Project No. 2023_079

MIDLOTHIAN ISD FRANK SEALE MIDDLE SCHOOL
INDOOR GOLF FACILITY

December 20, 2023

3 S-00 WALL PARTITION
1 1/2" = 1'-0"

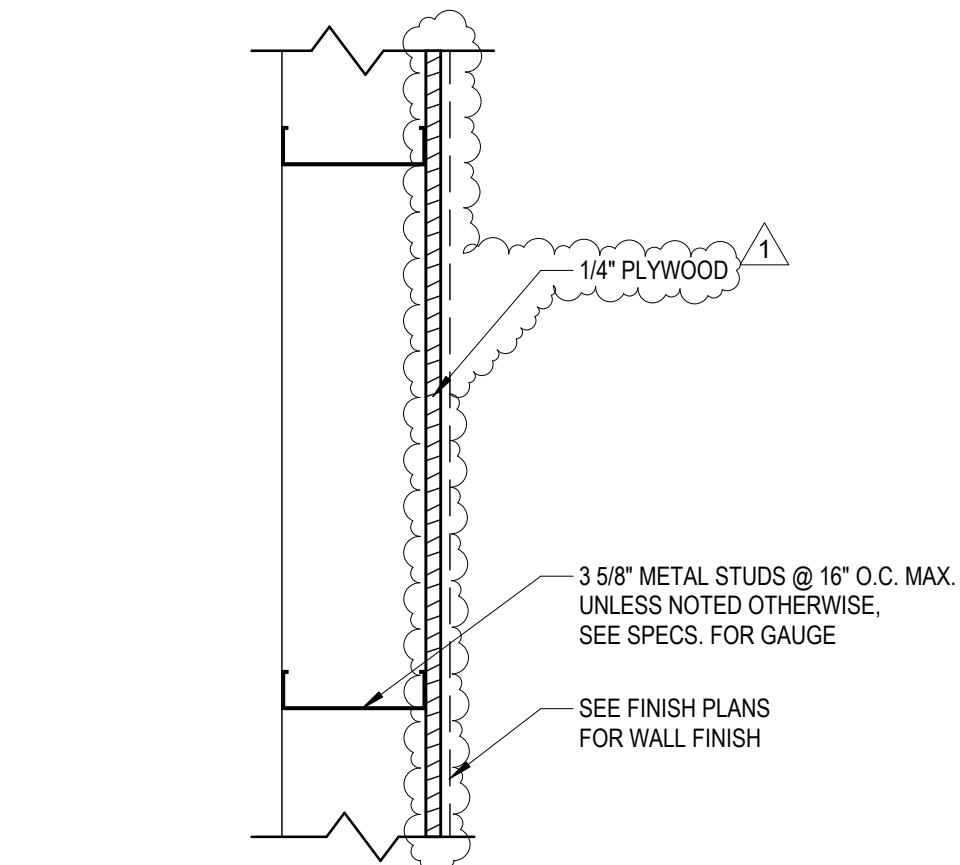
1. Added note to use trackman 4 indoor only technology on floor plan.
2. Added note to use SYNLawn putt holes or approved equal.
3. Updated detail 3/S-00 Wall Partition to use Plywood.
4. Added note to demolition floor plan to remove aircraft cable above floor and patch holes in CMU block with block filler cement.
5. Added note flat screen TV by owner.

SHEET NO.
A-101
AGENCY NO.

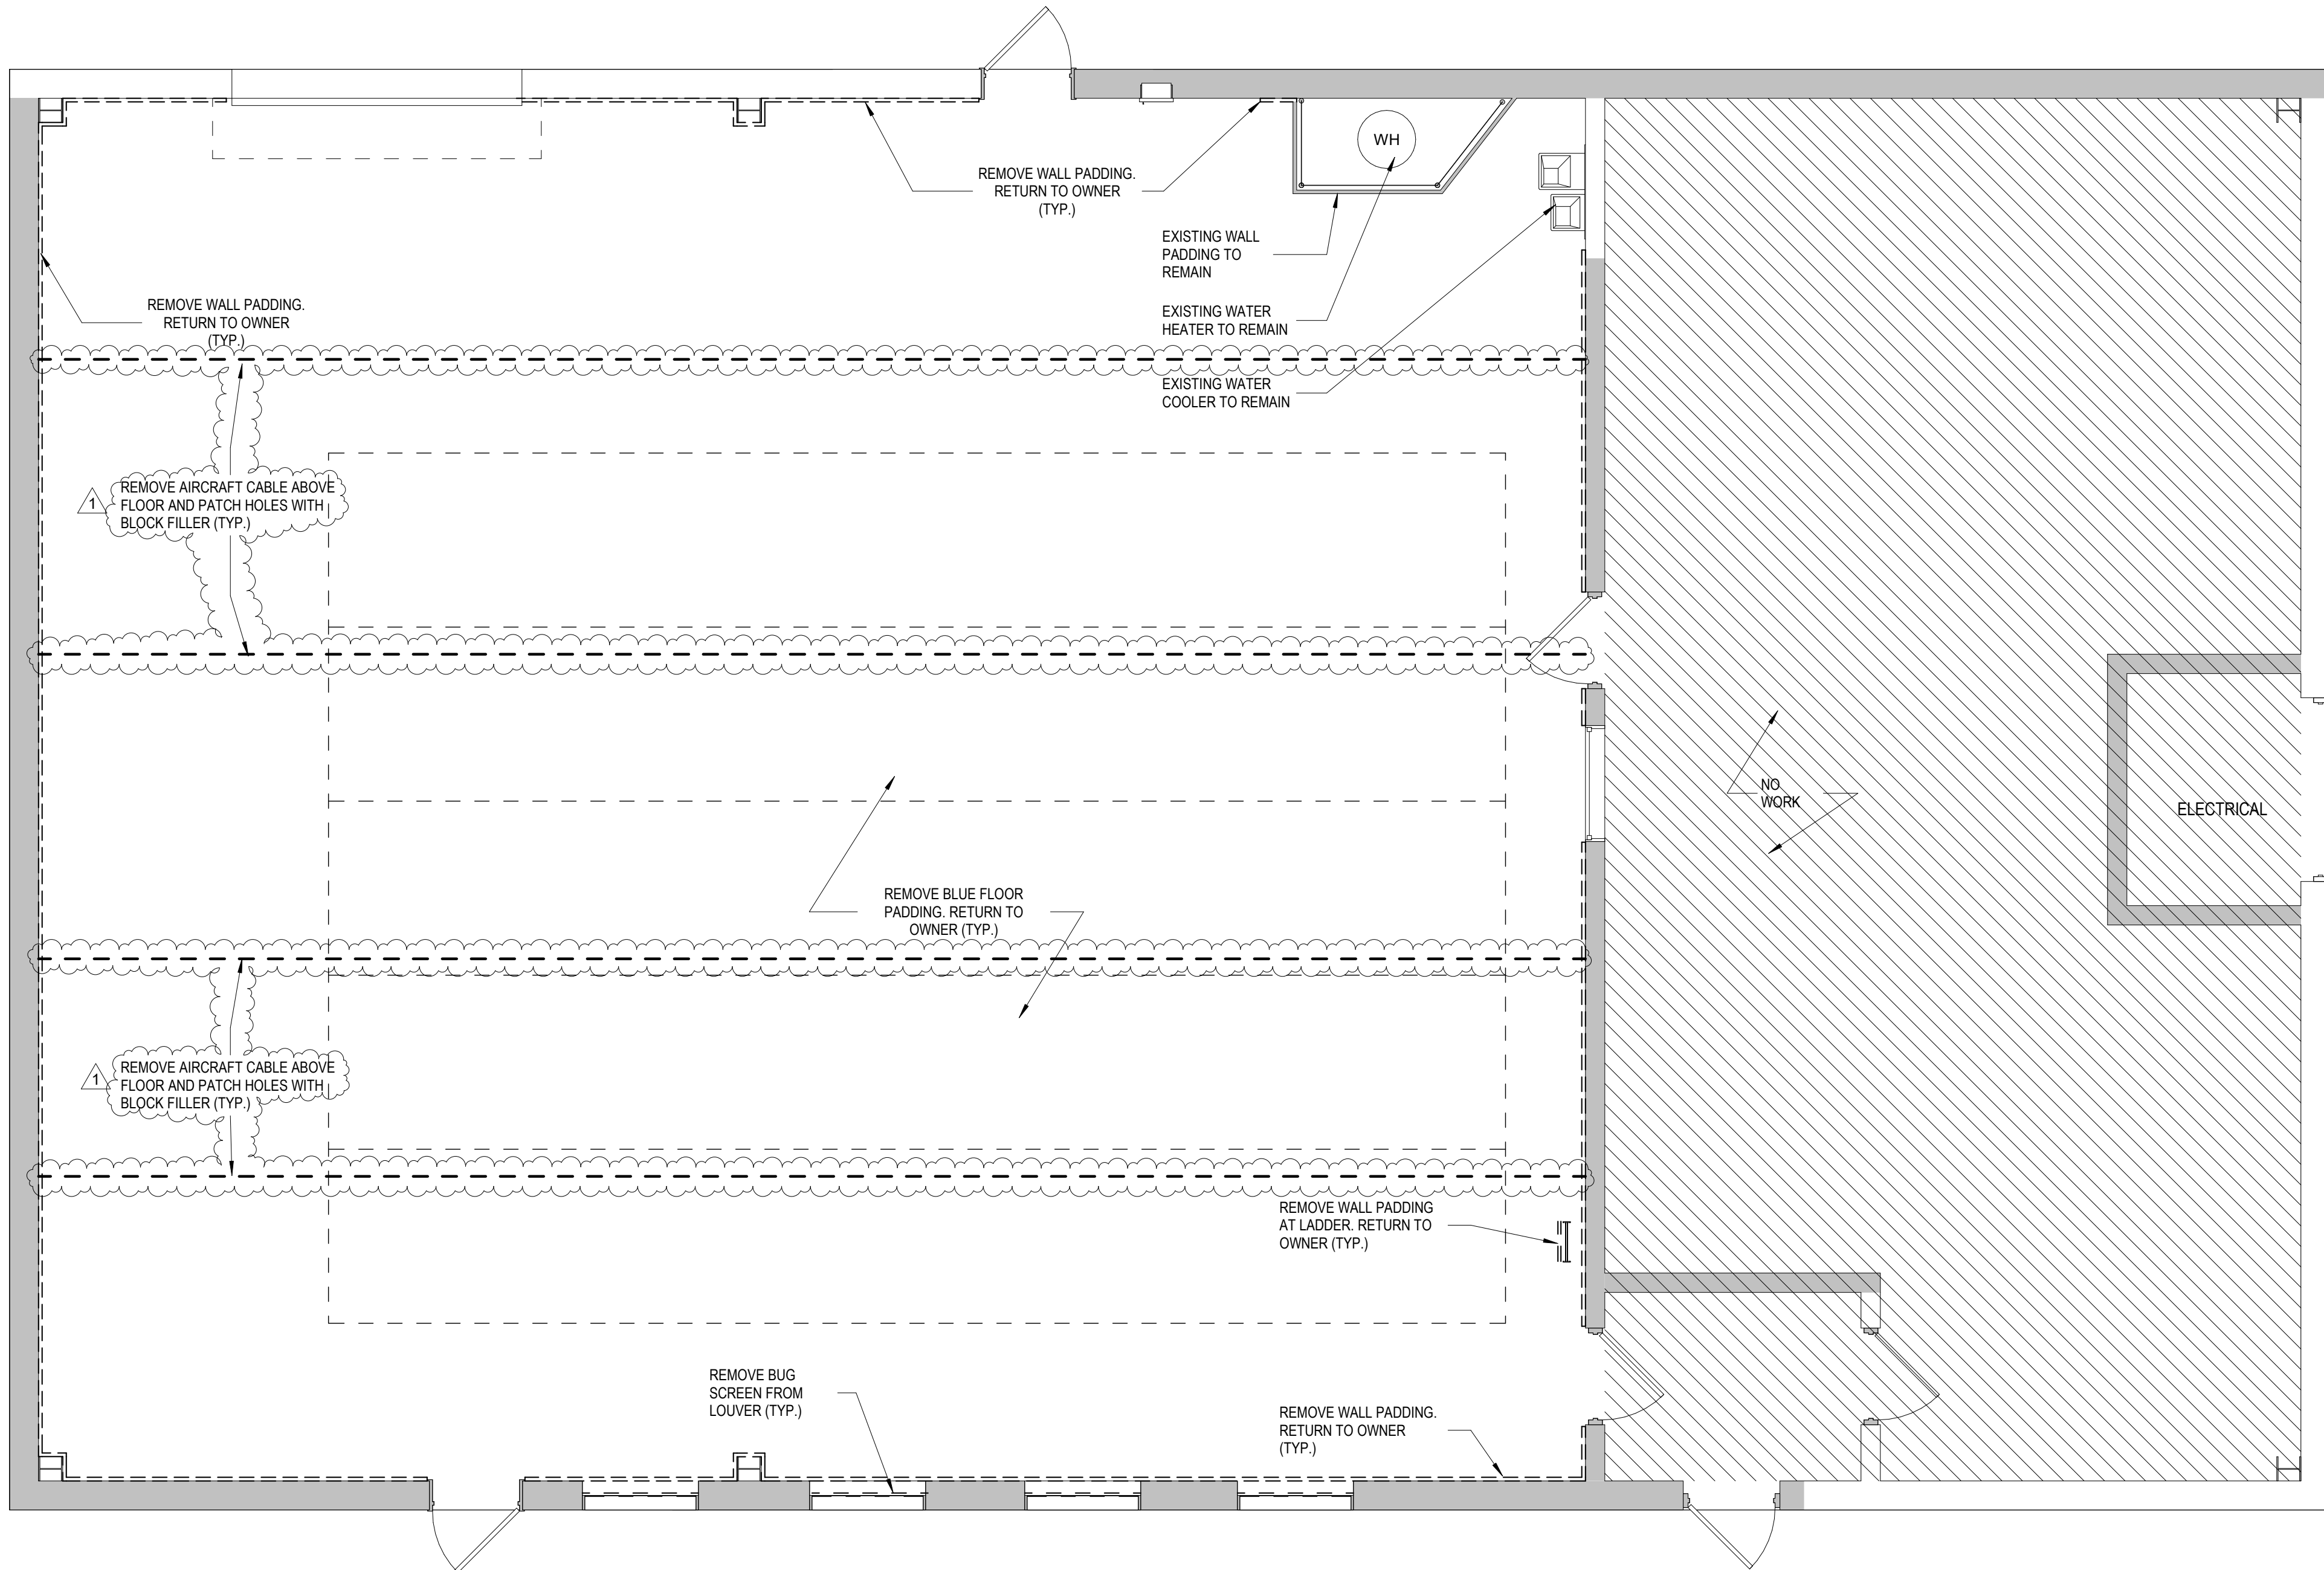
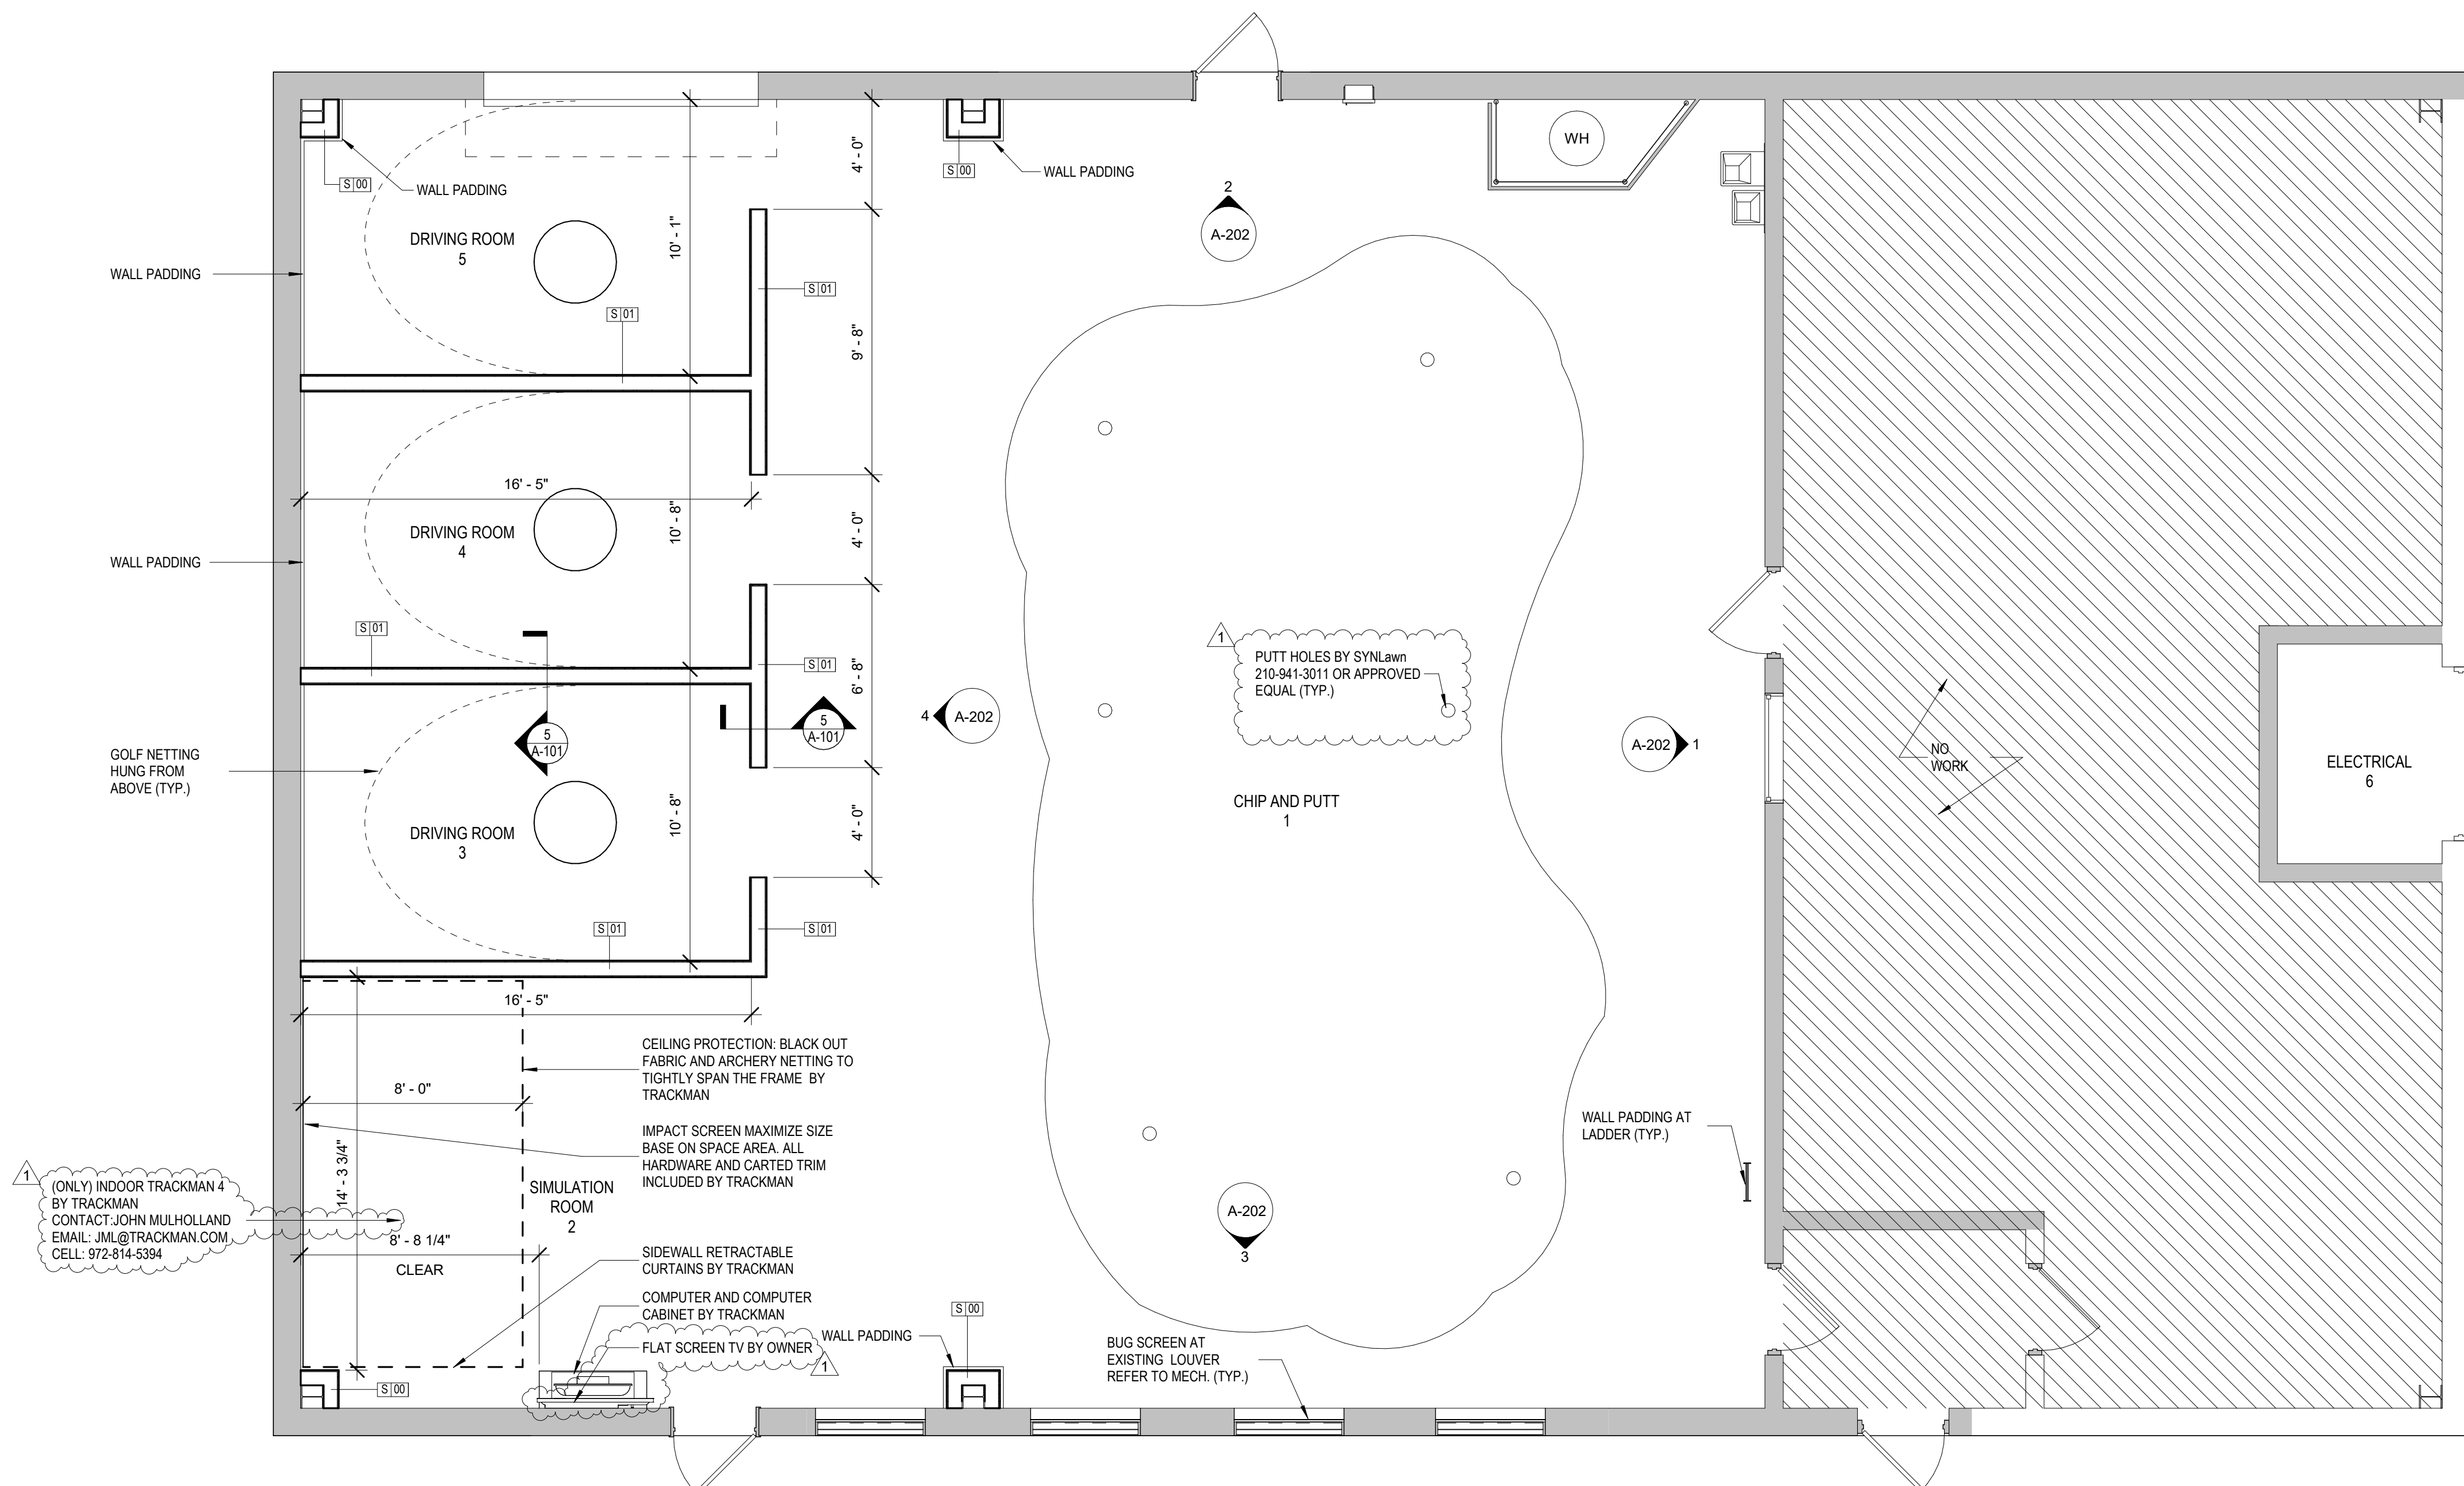
2. Will the wall padding called out at detail 2 on A-101 be existing wall padding reinstalled or will this be new wall padding, please advise?

New wall padding will be installed to match the school color blue. Contact architect/owner for correct colors.
